**NAVAL MEDICAL RESEARCH INSTITUTE  
BETHESDA, MARYLAND**

**81 - 47**

**HUMAN ENGINEERING EVALUATION  
OF THE  
HYPERBARIC RESEARCH FACILITY  
(PHASE 1)**

Fig. 3. Operating and local panels in master control area. Note extent of overhead piping.

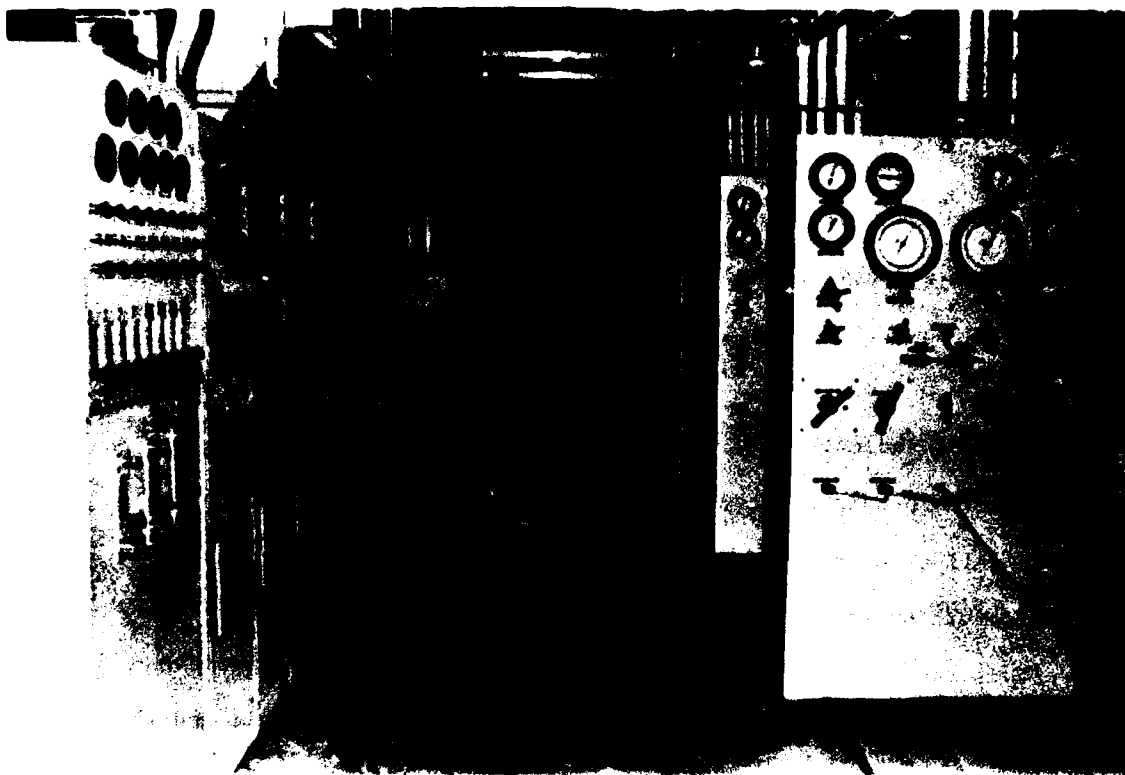
- (5) After much consideration, it is felt that completely enclosing the control area for purposes of sound attenuation is impractical due to the extent of overhead piping (Fig. 3). The major sound sources should be attenuated if possible at their sources (i.e., ACS blowers and building air conditioning). A solution involving the wearing of

Fig. 5. Possible layout for a central monitoring console to accommodate the diving officer, diving supervisor, and log keeper.

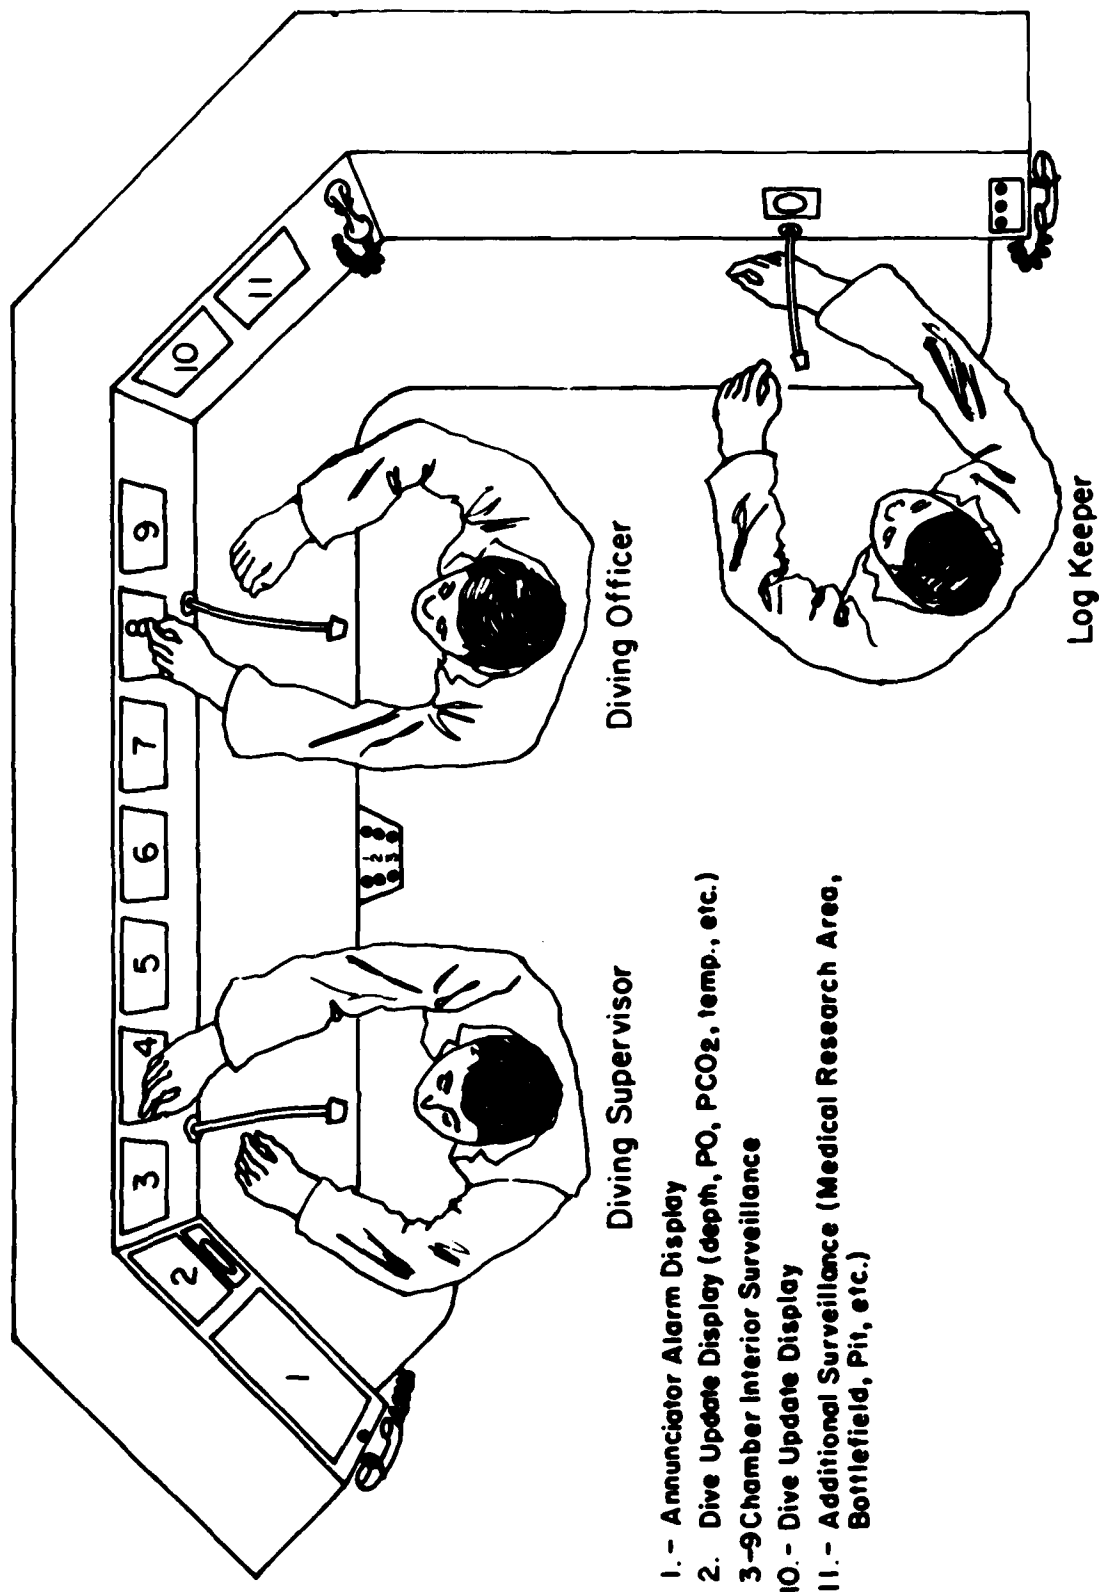
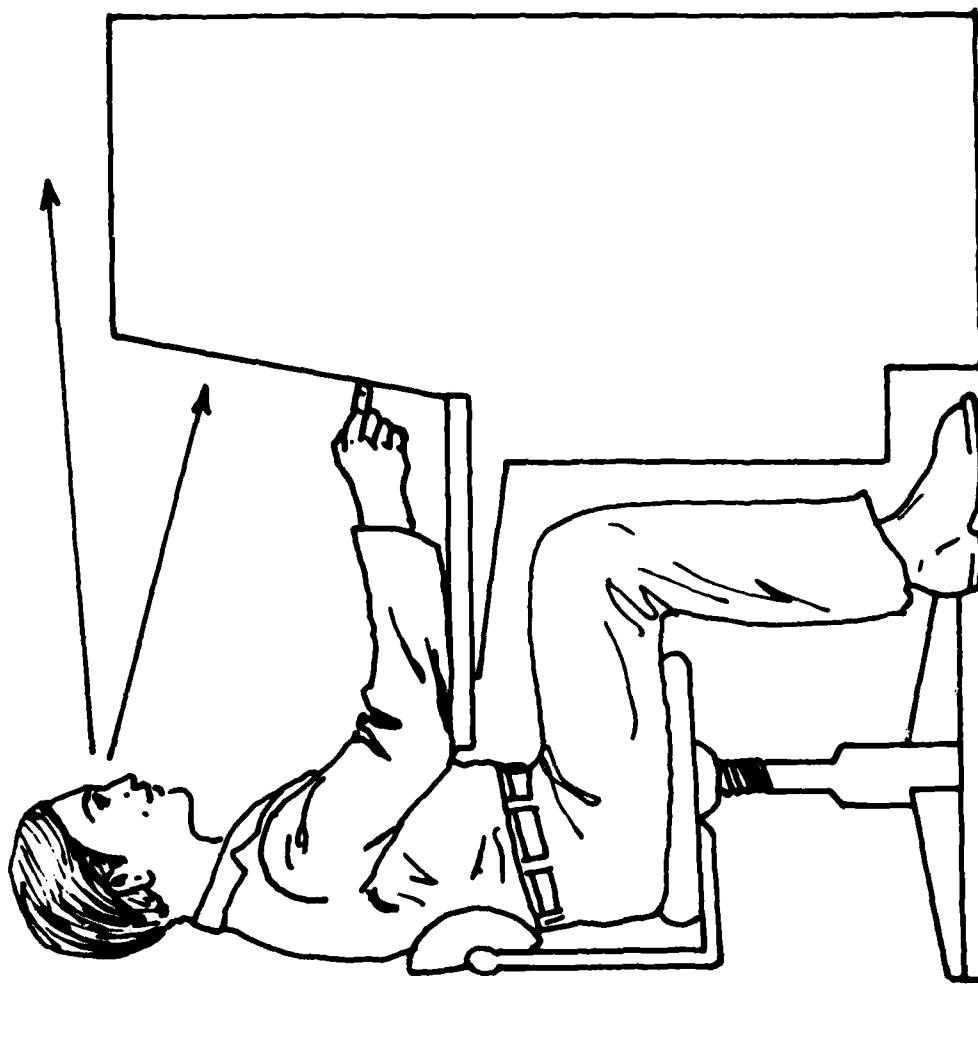
- (7) The present console design does not provide an adequate diving officer and diving supervisor watch station. Such a watch station should function primarily as a central monitoring location. Figures 5 and 6 show a recommended layout for this watch station. Figure 7 indicates the suggested location for the station. This location provides a complete view of the master control consoles, as well as easy access to the medical research area and visitor observation areas.

Fig. 7. Recommended location of central monitoring console.

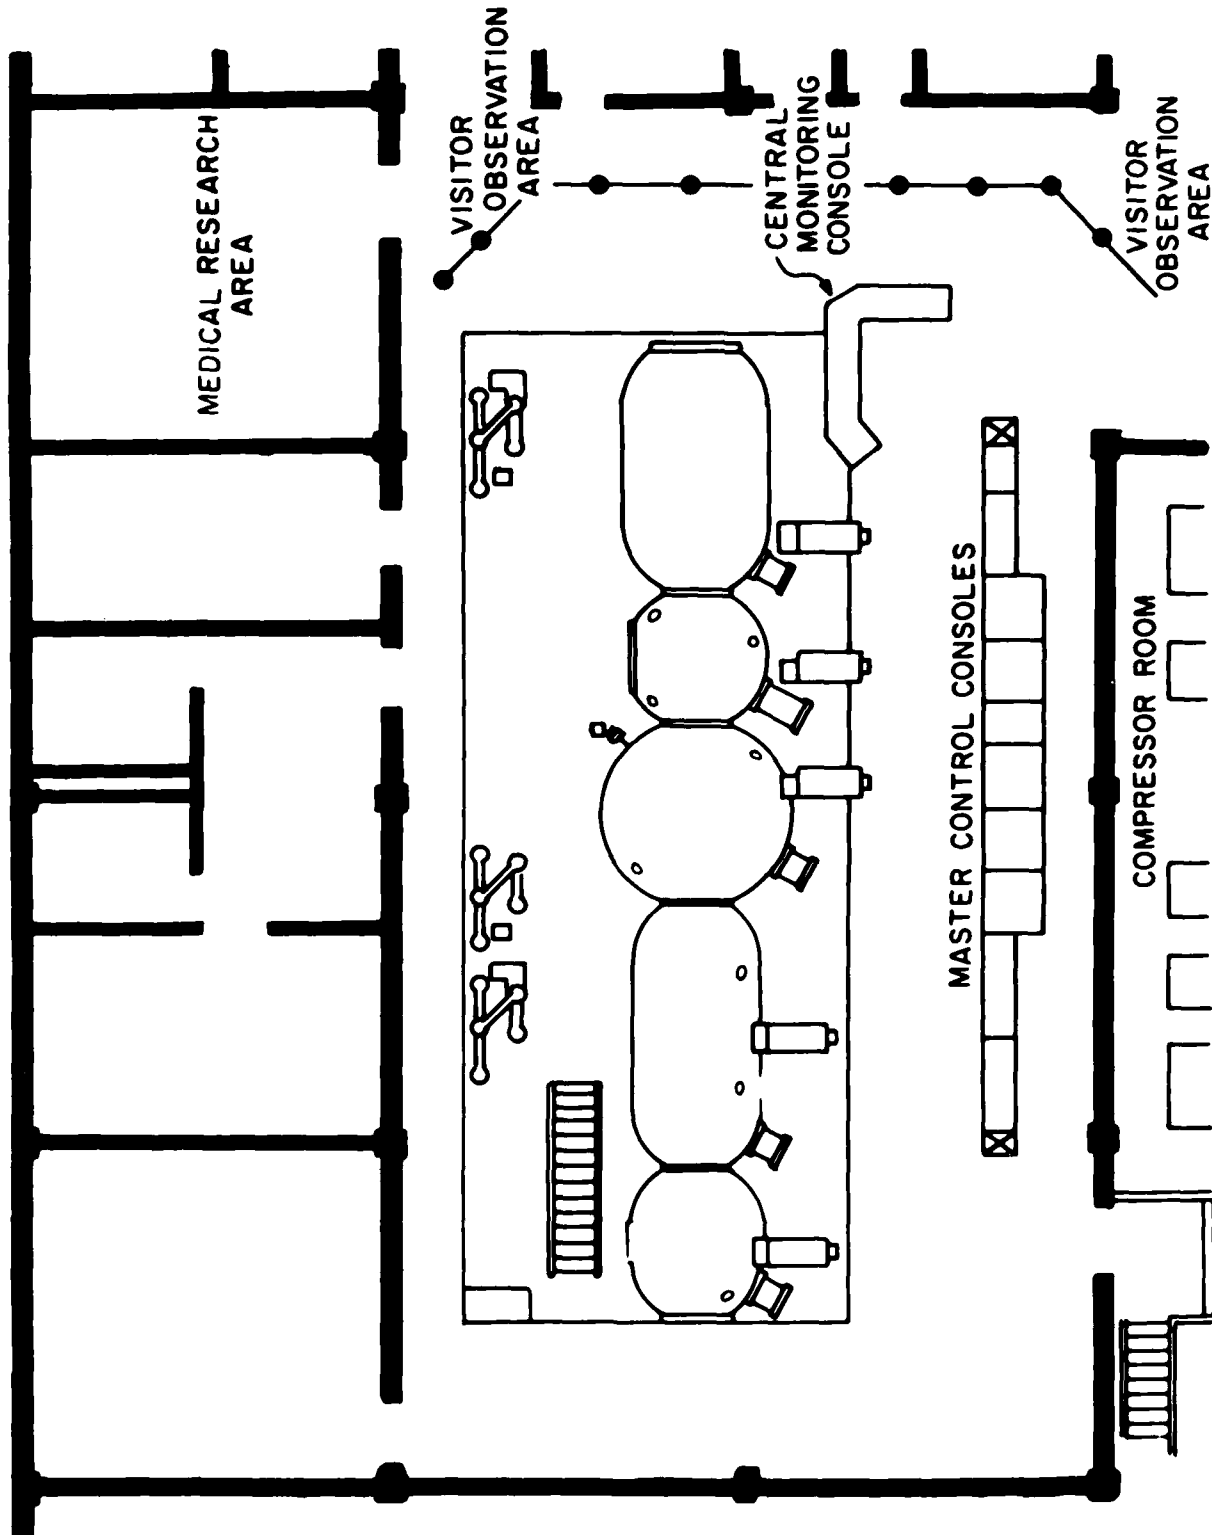
Until now, a location for the biomedical research equipment and research personnel during diving operations was not allocated. The recommended site for such a capability was shown previously in Fig. 7. (Priority 1)

Fig. 8. Local panel with sound-powered phone cord amidst panel valving.

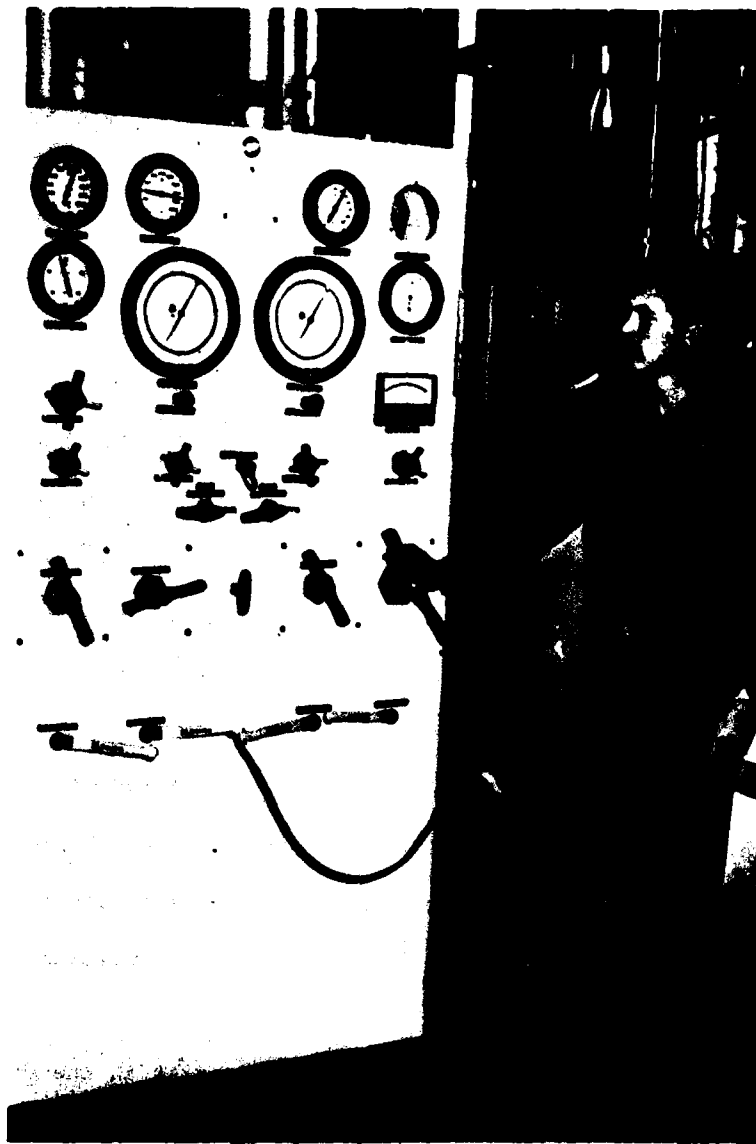
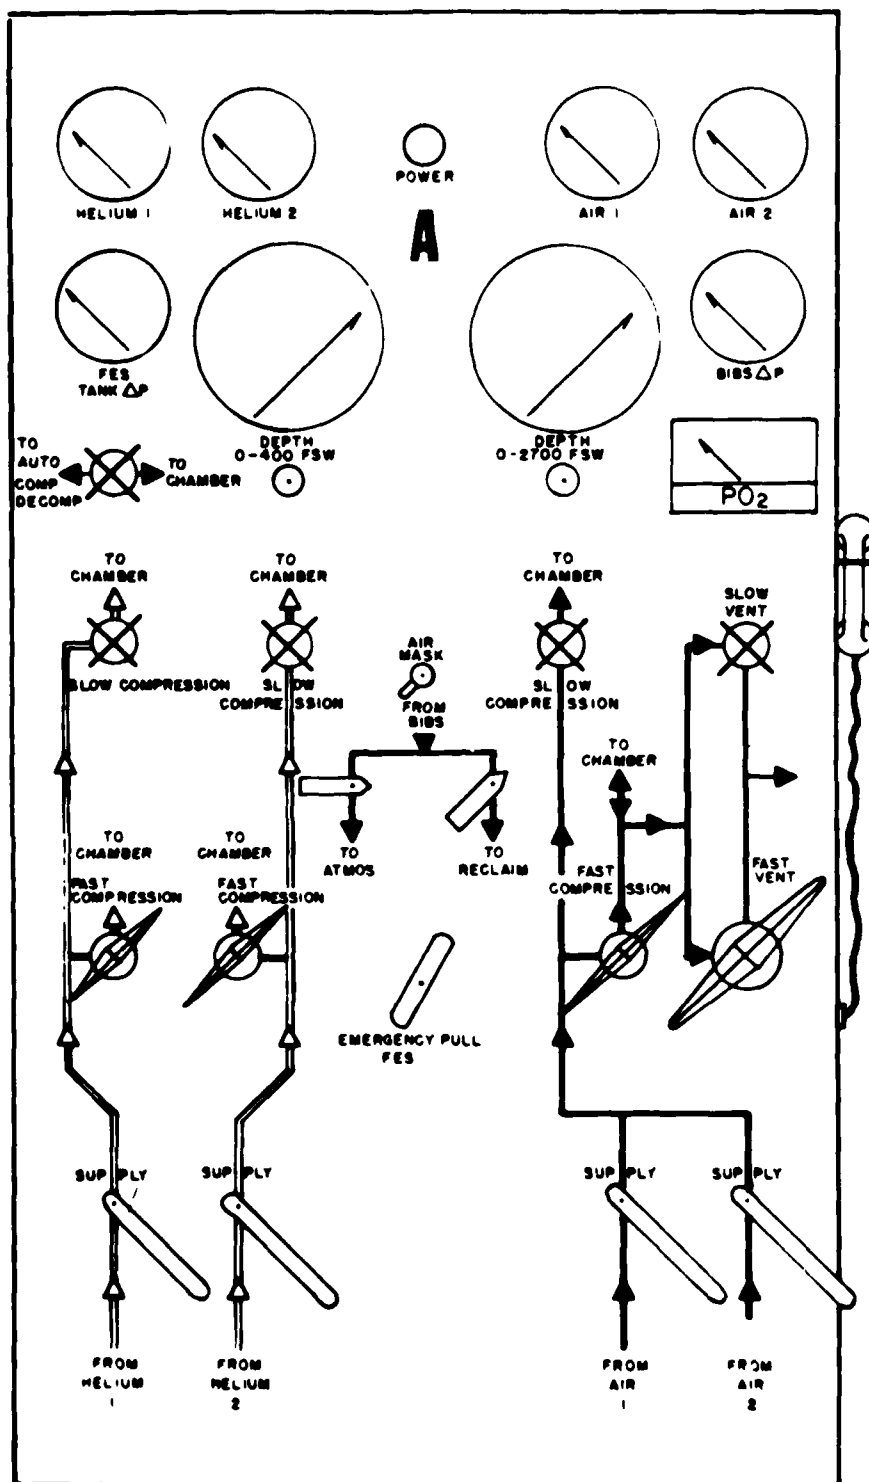
- (53) Figure 30 shows the present gas analysis instrumentation panel. The recommended changes are similar to those above (see Fig. 31). (Priority 2)
- (54) Figure 8 showed the face of a local control panel. Greater clarity of function can be obtained by concise gas paths and simple noncoded labeling. The recommended scheme is shown in Fig. 32. (Priority 2)

Fig. 32. A proposed layout for the local control panel. Gas paths would be appropriately color-coded.

Fig. 9. Present design of external medical lock hatch.

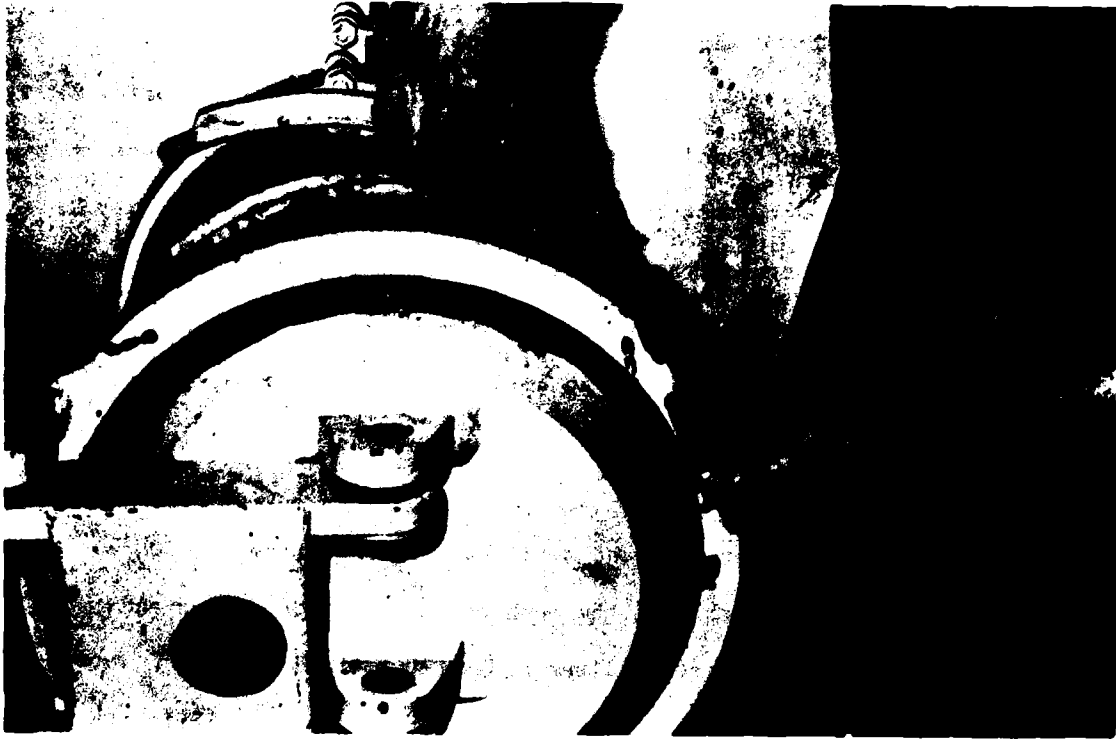
- (17) The present design of the external medical lock hatch causes inefficient and time-consuming delays in its opening and closing (Fig. 9). Alternative design configurations should be investigated. (Priority 1)
